# *NIC-FPS Critical Design Review*

## *Instrument Overview & Science Capabilities*

*Jon Morse  
(CU-CASA)*

*26 July 2002*

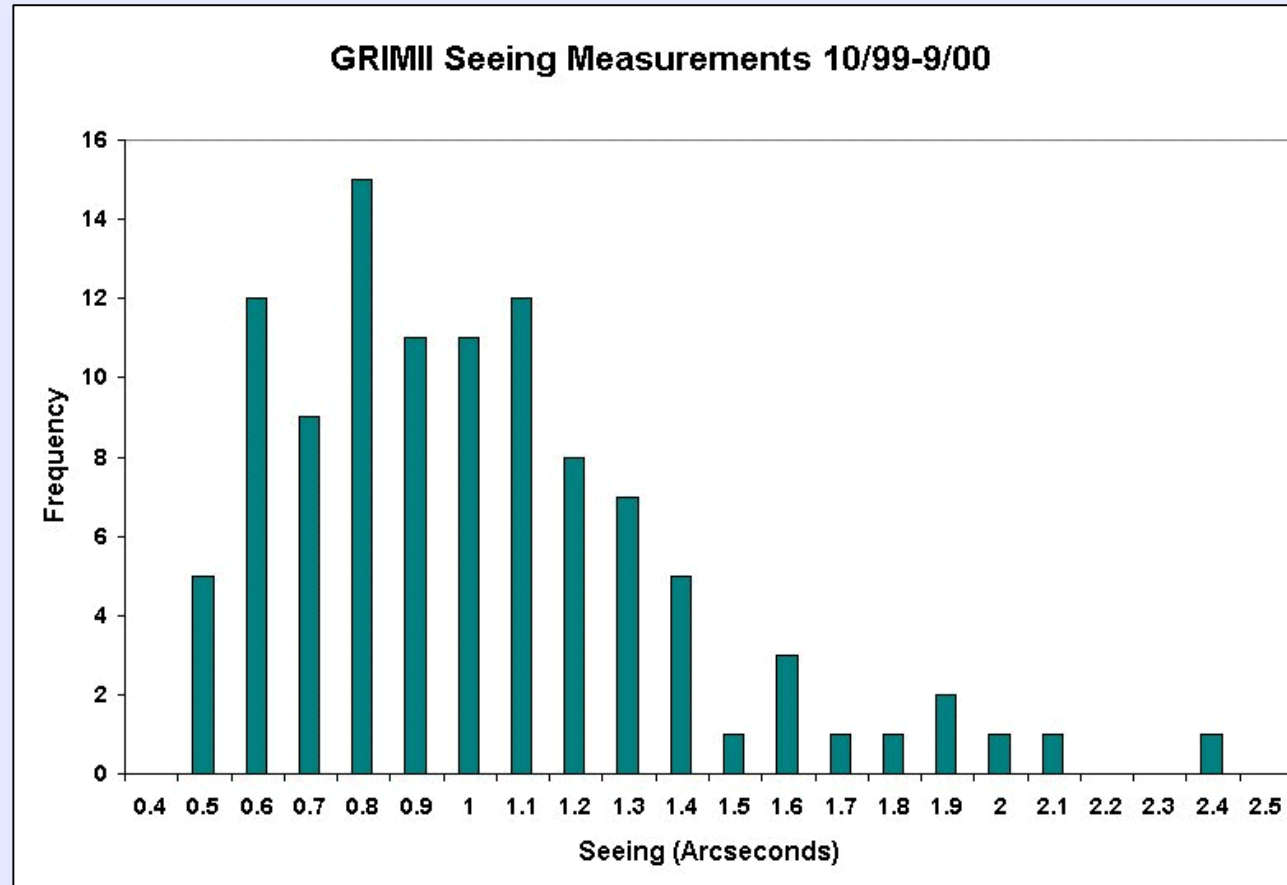
What is the impact to choice of pixel/arcsec if PSF improves from ~0.8 arcsec to 0.5 arcsec on average, and sometimes as good as 0.3 to 0.4 arcsec.

The image scale at the FPA is 0.27 arcsec/pixel (18 micron pixel size for the H-1RG). The optical design supports good image quality with 2 pixel sampling over essentially the entire FOV. Optical and NIR seeing statistics from APO suggest a median seeing of about 0.8 arcsec FWHM, with occasional performance as good as 0.5 arcsec. For seeing conditions of 0.5 arcsec or worse, the instrument should not drive the imaging performance.

If the NIR seeing improves substantially --- for example, if a tip-tilt capability were implemented on the secondary --- so that 0.3-0.4 arcsec seeing conditions were common, we recommend upgrading NIC-FPS with a new set of camera optics and a 2kx2k chip (Hawaii-2RG). We have already modeled the imaging performance of this upgrade \*within the available space on the NIC-FPS optical bench\* and find that an H-2RG option with about 0.15 arcsec/pixel would increase the FOV slightly and provide good image quality with 2 pixel sampling. An H-2RG would cost about \$350k, but we should be able to operate it with our existing "NGST" packaging and drive electronics. (The package is modularly designed so that we would literally just plug the H-2RG into the socket.) The new camera optics would probably cost between \$50-70k.
